2021 Electric Integrated Resource Plan

Appendix C – Public Participation Comments

IRP Comments Provided by Technical Advisory Committee Members

Electric Heat Pumps

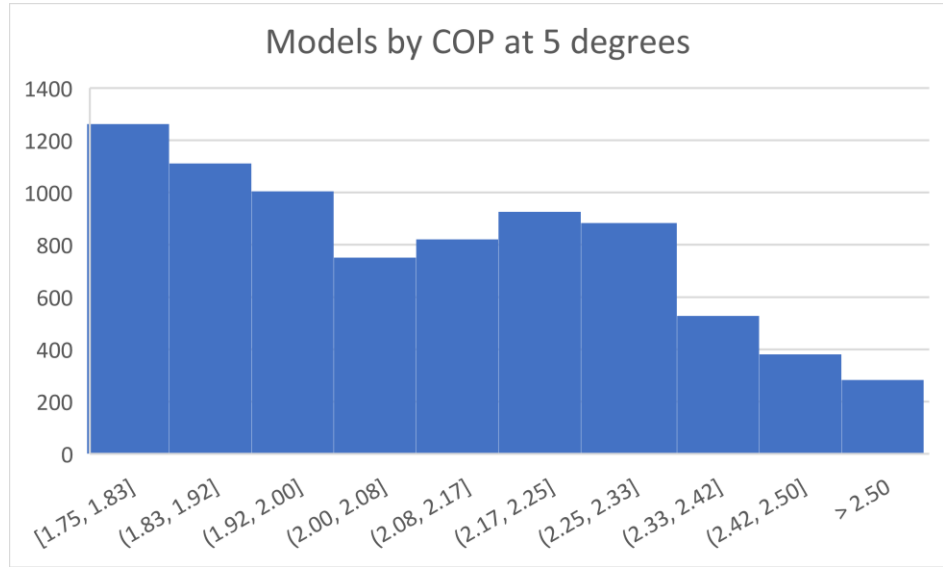
Avista suggests that end use efficiency of electric space heating at 35 degrees would be 150% (COP=1.5) and 100% at 5 degrees (COP=1). This does not accurately reflect the current state of the market. Climate Solutions reviewed the Northeast Energy Efficiency Partnership's (NEEP) [Cold Climate Air Source Heat Pump List](#). NEEP's definition of "cold climate" is any [IECC climate zone](#) of 4 or higher. Avista's service territory meets this definition, containing zones 5 and 6. NEEP's list contains nearly 8,000 air source heat pumps available on the market today from 89 manufacturers.

The average COP for the listed heaters operating at their maximum capacity at 5 degrees Fahrenheit is 2.09, and the lowest COP for the models they catalogue is 1.75 at that temperature. A number of models do indicate they would switch to backup heat at lower temperatures, but 4 out of 5 do not include a condition for switching and

Water Heaters

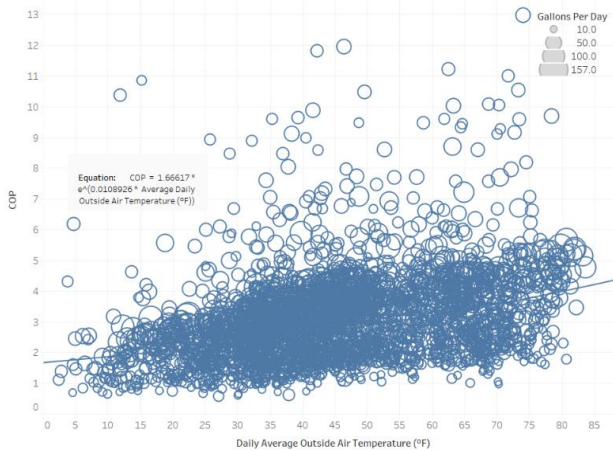
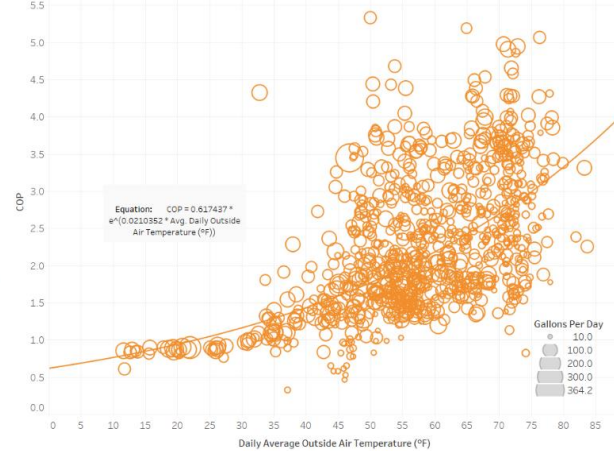
While there are heat pump water heaters (HPWH) available that perform at the low level Avista selected for 5 degrees, we do not think selecting the bottom of the market is a prudent choice. In 2018, Energy 350 completed field tests in a variety of conditions of HPWHs in British Columbia, including at locations that lie just outside of Avista’s service territory. A summary of their results are available [here](#).

Energy 350 chose two HPWHs, one from Sanden and another from Rheem and evaluated their operation over the course of a year. The Sanden model was a split system, with a unit located outside, while the Rheem model was designed to directly replace a traditional water heater located in conditioned and semi-conditioned spaces. Their COP results bear out these differing designs. On the next page are scatter plots showing the observed performance of these systems at various temperatures, along with their lines of best fit.

Rheem indoor option, so we would consider the proposed representative water heater the company is suggesting to be an exceedingly rare configuration on Avista's system.

For this reason, we request that Avista explain the assumptions the company is making about water heater locations, the ambient temperatures the model anticipates the water heaters will be exposed to over the course of a year, and make adjustments to more accurately reflect the product and appliance location choices customers are likely to make. At a minimum, we consider the current efficiency selected in the August 6th presentation to represent a circumstance that wouldn't occur—an indoor model placed outdoors.

Space Heating Conversion

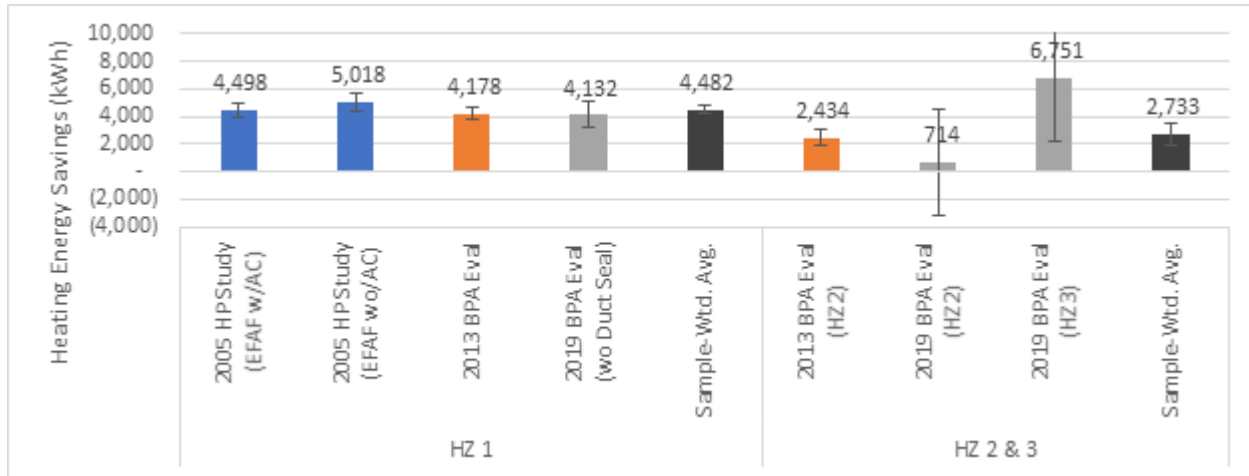
Fuel conversion from natural gas to electric heating will likely be to a central heat pump instead of a ductless heat pump system because current natural gas customers already have ducted systems in their homes and usually replace their heating systems with a centralized system. This situation also applies when adding a heat pump to the natural gas furnace. The central system heat pumps are not as efficient as ductless heat pumps because the system must work in conjunction with a furnace and duct system that was not created to perfectly pair with the heat pump hardware. A home with too little return air, or return air only coming from one floor, can reduce the rated efficiency of the heat pump. With a ductless system, all of the airflow characteristics are controlled by the heat pump manufacturer resulting in a more efficient unit.

Central systems require a defrost mode when temperatures are below freezing, reducing the efficiency below 100% if the consumer does not shut this feature off. We find this occurs in 80% of homes; therefore, we assume a 90% efficiency rating at very cold temperatures when a peak load would likely occur (given this analysis assumes a 10% efficiency credit we effectively model cold temperature at 100% efficiency). Heat pump systems in our climate also experience snow coverage where the homeowner would need to physically create air space around the unit. This often does not occur during periods of inclement weather and further reduces efficiency.

Ductless Heat Pumps

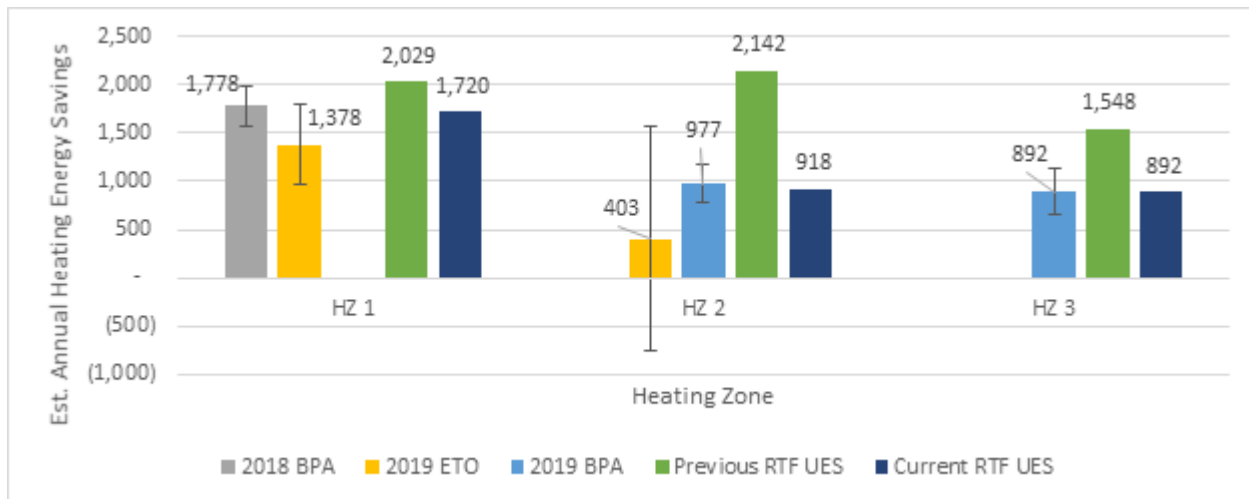
If a natural gas home converts to a ductless heat pump system (DHP), the whole house would not see a COP in the 3 to 5 range for homes with cold temperatures as commonly advertised by the vendors. First, the amount of BTUs produced in a ductless system significantly reduces as temperatures decline. This requires the system to run longer, contain more units, or be supplemented with additional resistance heat to maintain house temperature. Further, most homes with DHP do not use this system for the entire house and typically only heat one or two rooms while putting very low cost resistive heating in smaller rooms and areas of the house not frequently used.

Practically, in colder temperatures, it is possible to have a whole house heating COP above 1, but it is likely to be closer to 1 than 2 given the other heating requirements. Avista will revise IRP modeling to include some new homes using ductless heat pumps with slightly better than 1 COP values. The following graph from the current DHP data shows a savings in heating zones 2 and 3 of less than 920 kWhrs per unit installed. This is in homes where the average annual heating consumption is over 5,000 kWhrs. The best study here also shows other fuel influences like wood heat that can increase electric use due to the high cost of resistance electric heat after the addition of a ductless heat pump. This seasonal efficiency is less than a COP of 1.25.

Figure 1. Li-ion battery storage projection (in \$/kW) from NREL’s Annual Technology Baseline 2020.⁹

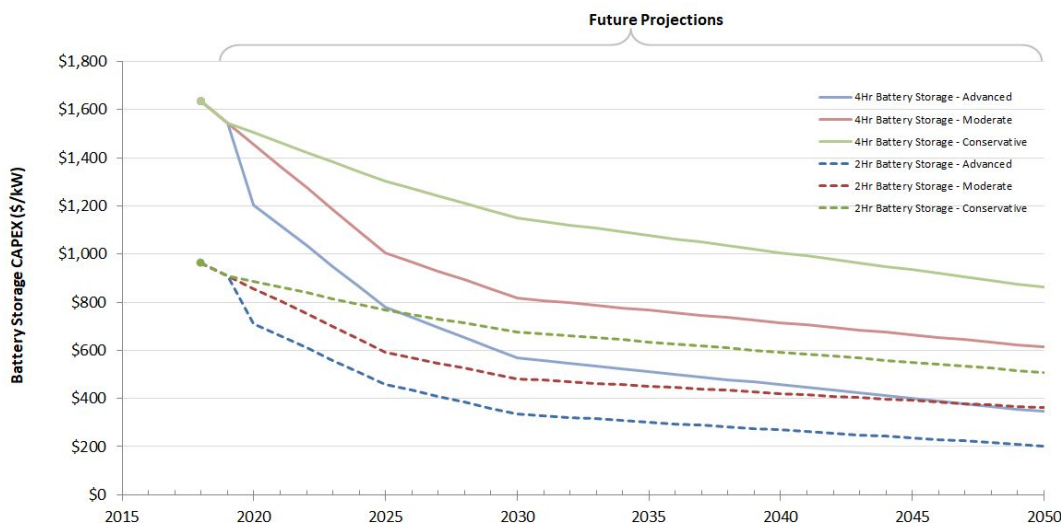
Considering Avista’s assumptions for lithium-ion battery storage, we recommend the Company review the data informing the levelized cost (\$/kW) for the preferred 4-hour lithium-ion battery, as there appears to be a gradual price increase after 2033 rather than a steady decline, which would be expected.⁸ For example, the National Renewable Energy Laboratory’s (“NREL”) 2020 Annual Technology Baseline (“ATB”) reports a trend of cost reductions (illustrated as \$/kW in *Figure 1*) through to 2050.

Figure 9.1: Lithium-ion Capital Cost Forecast

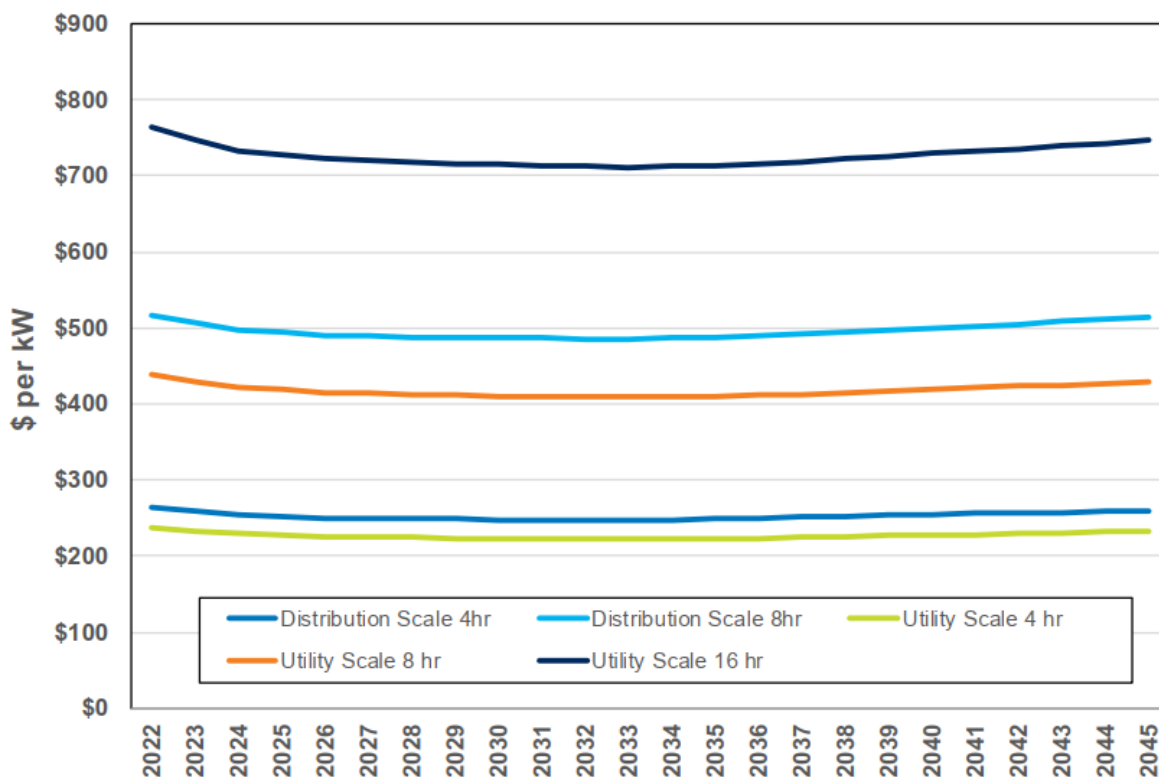
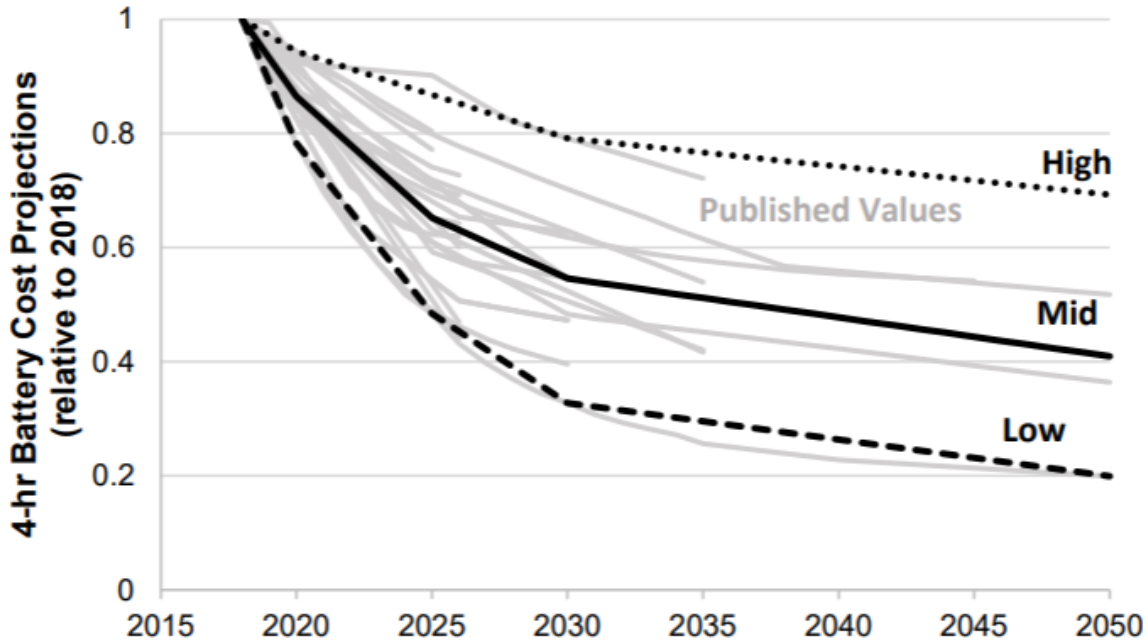
However, the future costs for batteries and pumped storage simply don't seem reasonable. The values in Figure 9.1 show slight declines in battery costs, and then flat or rising costs through the remainder of the planning horizon. Most other estimates show consistently declining costs through the coming decades, though at varying rates.

Figure 2: 2020 Avista Capability and Energy Fuel Mix¹⁹

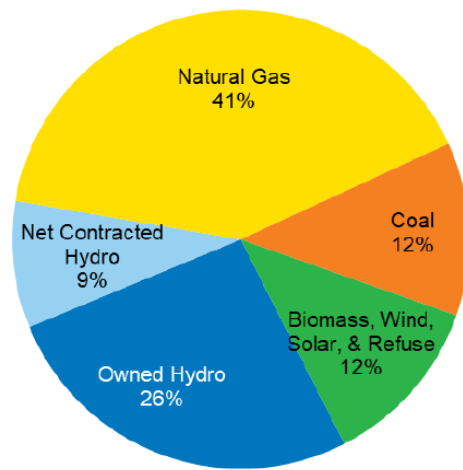
Further, to adequately account for the effect of climate change, Avista could consider acquiring additional expertise regarding temperature impacts over time on Avista's system, especially considering the company's hydro-reliance position, as shown in Figure 2. Staff suggests the company take a closer look at the methods peer utilities are taking. For example, Seattle City Light included a study on "Climate Change Effects on Supply and Demand," as an appendix to its IRP, dedicating resources to assess the IRP climate sensitivity on the utility's load-resource balance, including reduced snowpack, earlier melt, higher winter inflows, and lower summer inflows. This additional information provided insights into climate change scenarios' effects to potentially change the *expected base portfolio* for supply and demand.¹⁸

Figure 3: Washington Energy Efficiency Avoided Cost²⁴

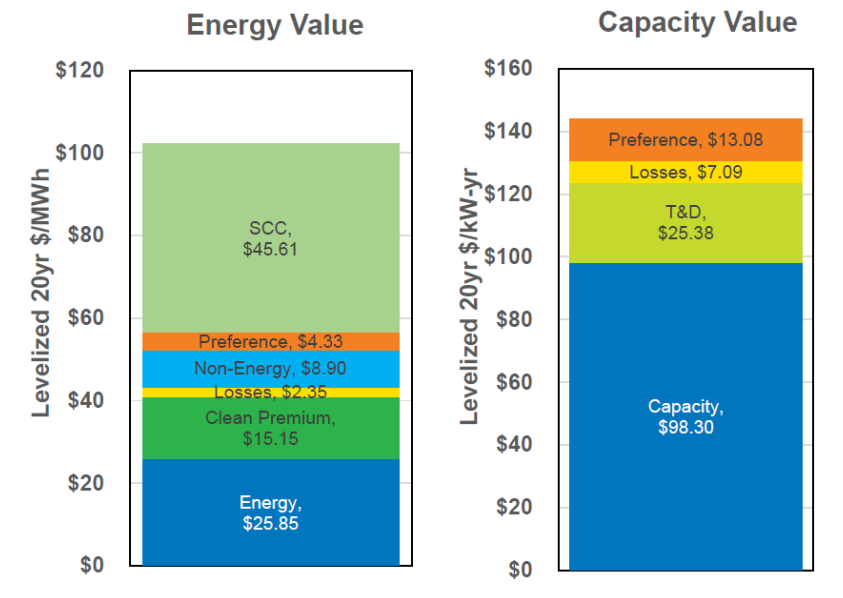
Figure 3 below shows the avoided cost of EE for energy and capacity with components broken out. Over the planning horizon the levelized price of EE is projected to be 3.5 cents per kWh.
